New Cassel / Hicksville Groundwater Contamination Superfund Site (Eastern Plume)

I. Amendments to Unilateral Administrative Order (UAO) Pre-Design Work Plan (PDI Work Plan or PDI WP)

II. COMMENTS ON THE DRAFT EASTERN PLUME FIELD SAMPLING PLAN AND SITE MANAGEMENT PLAN

III. Comments on the Draft Quality Assurance Project Plan (QAPP)

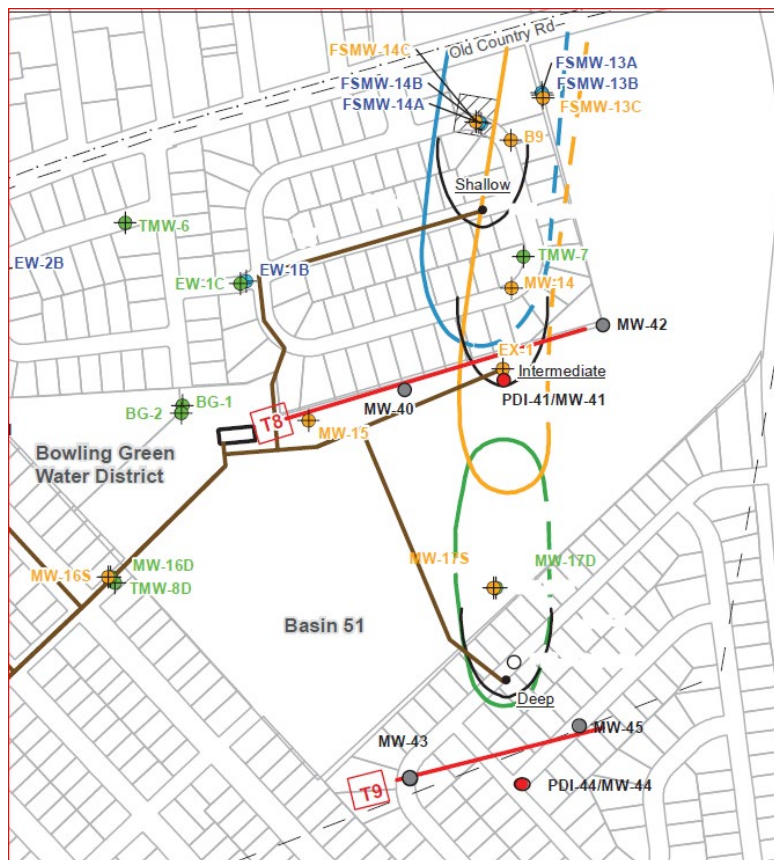
1. Transect 7 (T7): Profile borings and monitoring wells along T7 shall be eliminated.
2. Transect 8 (T8): Install a profile boring and a monitoring well at PDI-41/MW-41 in accordance with the figure below. All vertical profile groundwater sampling shall include a sample at the groundwater interface, estimated to be approximately 40 feet below ground surface (bgs) and extend from 120 feet bgs to 520 feet bgs at 20-foot intervals. Depending on the results of sampling at PDI-41/MW-41, EPA will determine whether borings and/or wells will be installed at MW-40 and/or MW-42. EPA will be the final arbiter of this decision.

3. Transect 9 (T9): Move T9 200-300 feet south (from the original location) towards the bend of the road on Choir Lane in accordance with the figure below. Drilling south of the OU1 southern boundary (e.g., corner of Crystal Lane and Cameo Lane) is acceptable within 500 feet from the boundary. Install boring/monitoring well PDI-44/MW-44 on Crystal Lane and either PDI/MW 43 on Crystal Lane or PDI/MW 45 on the western half of Cameo Lane. All vertical profile groundwater sampling shall include a sample at the groundwater interface, estimated to be approximately 40 feet below ground surface (bgs) and extend from 220 feet bgs to 520 feet bgs at 20-foot intervals. The approximate new locations are displayed on the figure below. Once EPA is in receipt of the data from the two borings/wells drilled, EPA will determine whether the 3rd boring/well will be required. EPA will be the final arbiter of this decision.
